Addendum Technical Note – Surface Water

- 1.1 An original Drainage Technical Note (TN) has been produced by White Young Green (WYG) to describe the proposed surface water strategy for the Lyminster Bypass. The TN, dated 22nd August 2017, is contained in Appendix A of this report.
- 1.2 Mayer Brown Limited (MBL) have subsequently been appointed as the Consulting Engineers who will undertake the detailed design the proposed drainage for the scheme.
- 1.3 The drainage strategy as described in the original TN has altered since the original August 2017 issue. The purpose of this addendum technical note (Addendum TN) is to summarise the changes that have occurred to the proposed scheme.

Persimmon Homes Thames Valley
Lyminster Bypass
Addendum Surface Water Technical Note

Author: Sean Foley

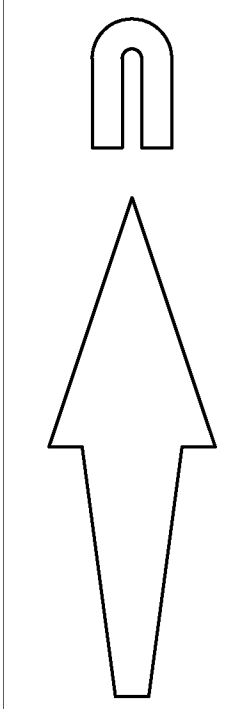
- 1.8 The drainage strategy for the Northern Catchment has undergone a significant alteration. The previously proposed surface water swale, attenuation tank and restriction of 10 litres / second have been removed (refer to paragraph 4.7 in the TN).

- 1.9 The proposal is to allow the surface water run-off to flow freely into the downstream drainage network and the pipe diameters have been sized accordingly. The proposed drainage network serving the northern catchment is contained in Appendix B of this Addendum TN.
